Response to Planning application from Hertfordshire County Council (T and CP GDP Order 2015)

District ref: 23/02492/FP
HCC ref: NH/18978/2023
HCC received: 17 November 2023
Area manager: James Dale
Case officer: Adrian McHale

Land At Roundwood , Back Lane, Graveley, Hertfordshire,

Comments on transport matters in full planning application 23/02492/FP

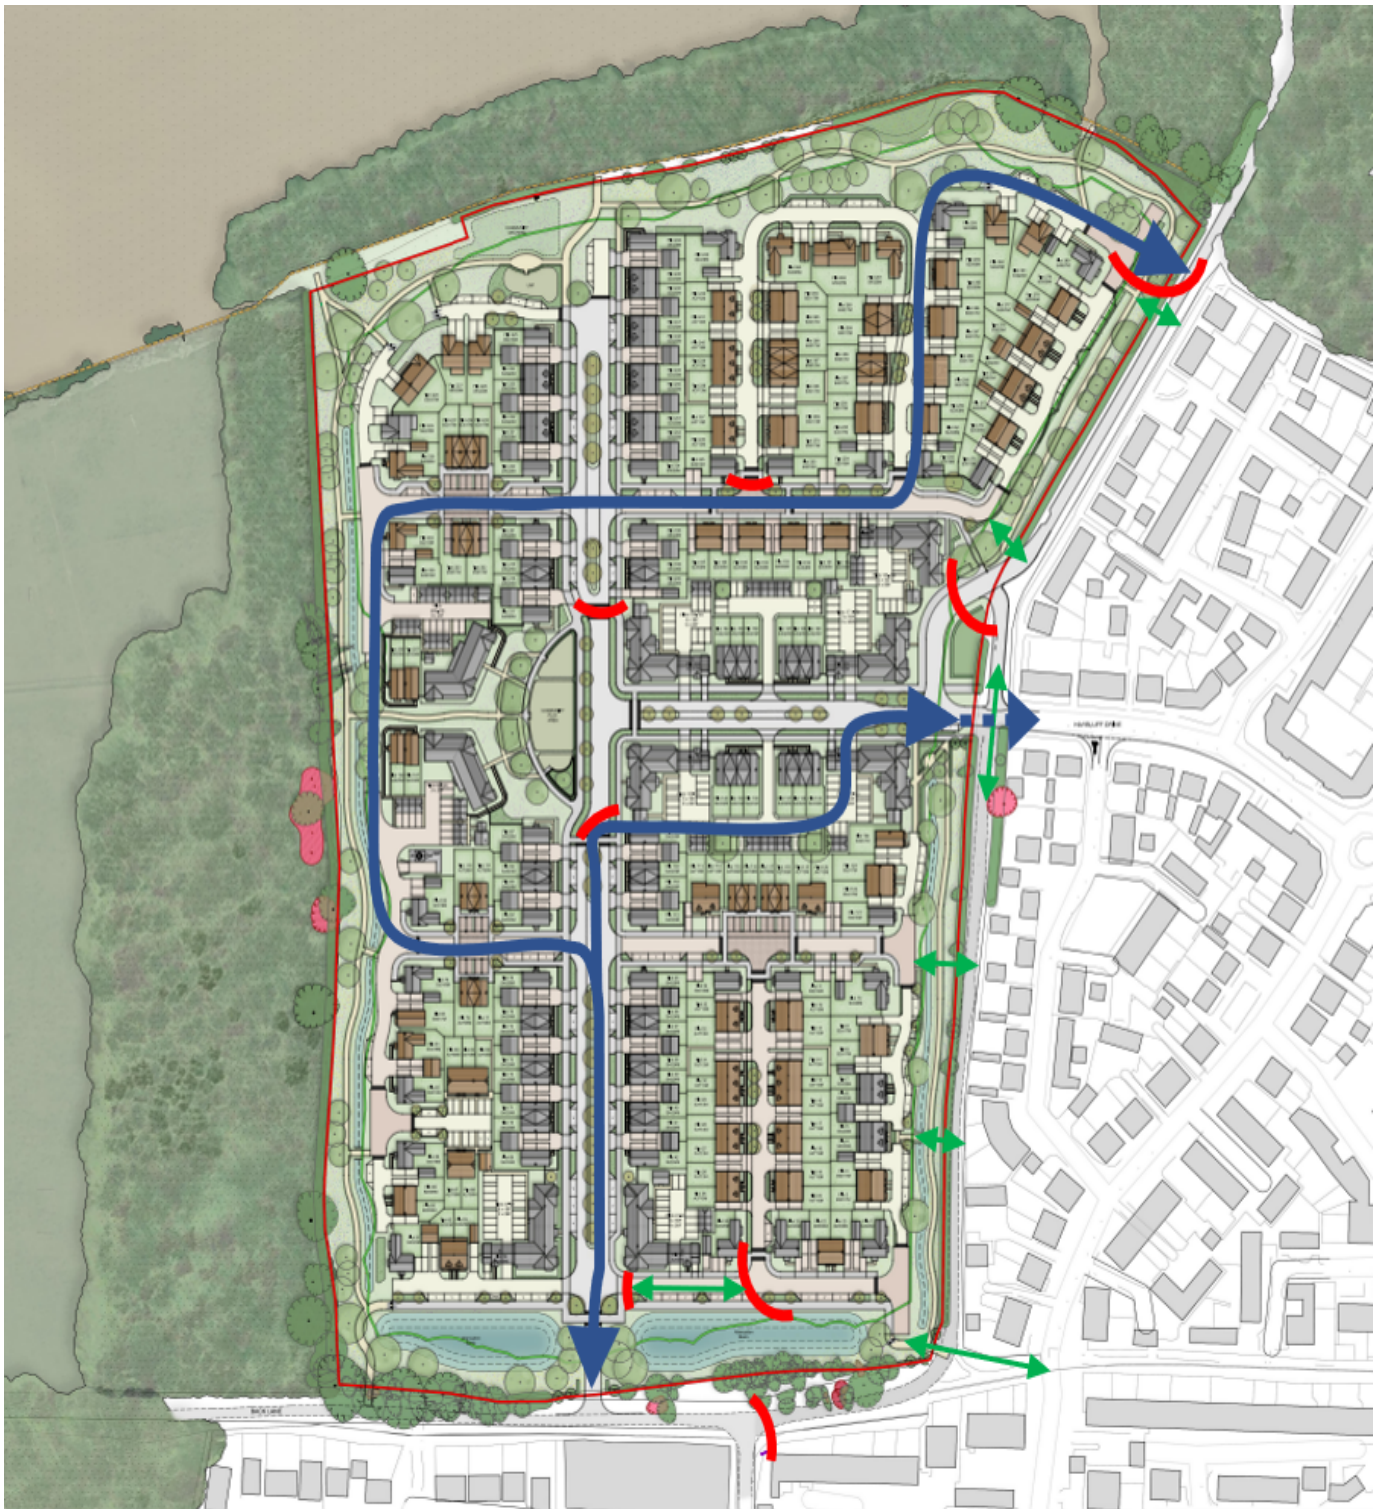
Relating to this HCC Highways consider that the proposed detailed layout will facilitate inappropriate 'rat running' which would be unsafe for existing and proposed residents of the Great Ashby area.

In pre application advice HCC Highways indicated a layout that would reduce any 'rat running' that was induced to use Haybluff Drive whilst ensuring access for essential users and promoting development in line with the councils policy.

The applicants transport consultant however proposes to address the 'rat running' issue through the provision of a 'No Left Turn' sign at their proposed Back Lane (incorrectly labelled Weston Road in the TA)/ Haybluff Drive junction. However, HCC Highways consider that this would be unenforceable and ineffective in this location, particularly given the nature of 'rat running' traffic, and a less 'convenient' route for deterrence is essential.

HCC Highways suggested the following layout, which maintained the proposed housing levels would be appropriate.

Figure 3: Potential diversions of SB7 bus route to serve GA1 and the northern part of Great Ashby

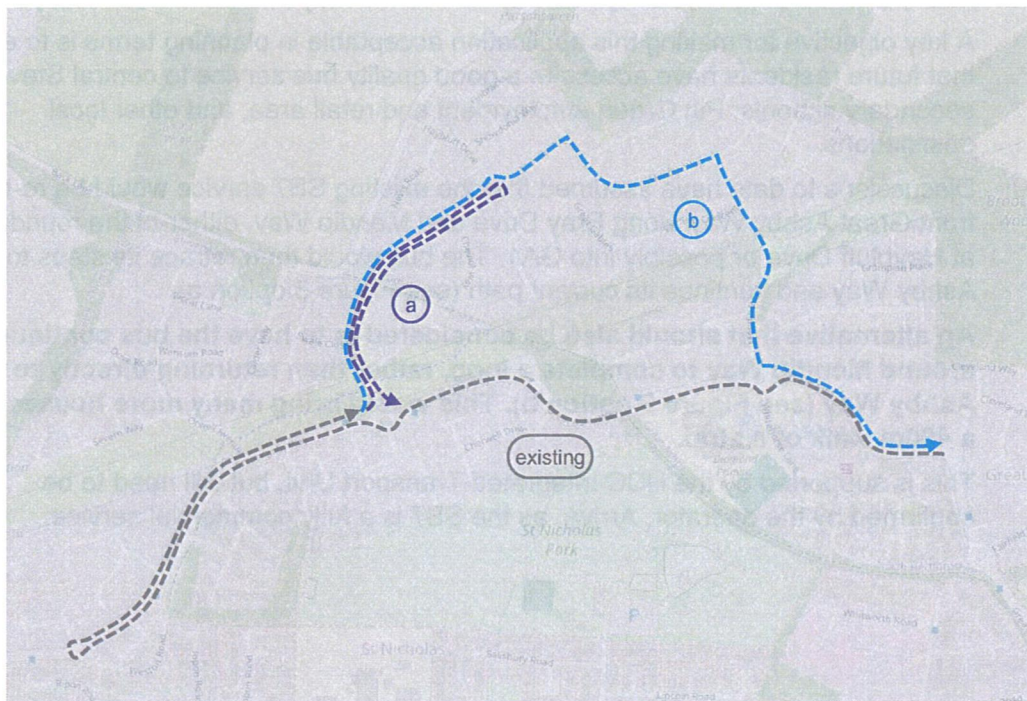
- 3.3 Discussions to date have assumed that the existing SB7 service would be re-routed from Great Ashby Way along Bray Drive and Mendip Way, either to the roundabout at Haybluff Drive or possibly into GA1. The bus would then retrace its steps to Great Ashby Way and continue its current path (see Figure 3 option a).

- 3.4 An alternative that should also be considered is to have the bus continue around Mendip Way to complete a loop, rather than returning directly to Great Ashby Way (see Figure 3 option b). This would bring many more houses within a 400m walk of a stop.**

- 3.5 This is supported by the HCC Integrated Transport Unit, but will need to be confirmed by the operator, Arriva, as the SB7 is a fully commercial service.

Figure 4: Garage dimensions

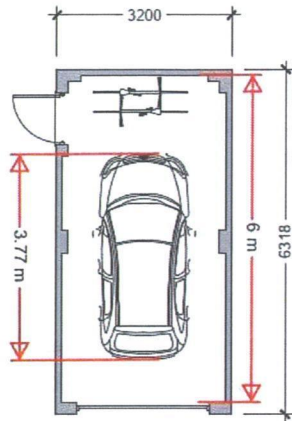
- 6.6 The internal depth of the garages appears to be 6m and the vehicle illustrated in the plans, 3.75m (see Figure 4). The more typical length of a family car is around 4.5m (e.g. a Ford Focus or a Kia Sportage). Estate cars and many SUVs measure around 5m in length. Allowing space for the sweep of the garage door, there would be insufficient space to manoeuvre more than one cycle in and out. If the back of the garage is used for storage or a workbench, there would be no room for any cycles.

- 6.7 It is understood that the garages are not being counted as contributing to the parking allocation (and research¹ indicates that over half of existing garages are not used to park cars), but this potentially wastes a considerable amount of land. If the intention is to provide a storage/workshop space, it may be more appropriate to design the outbuilding for this purpose, rather than provide an undersized garage.

- 7.6.5 Consider provision for delivery vehicles with dedicated loading or short-stay bays.
- 7.6.6 Reconsider garage dimensions to ensure they can serve successfully as cycle parking spaces: either to make them deeper or purposefully design them as secure storage/workshop spaces.
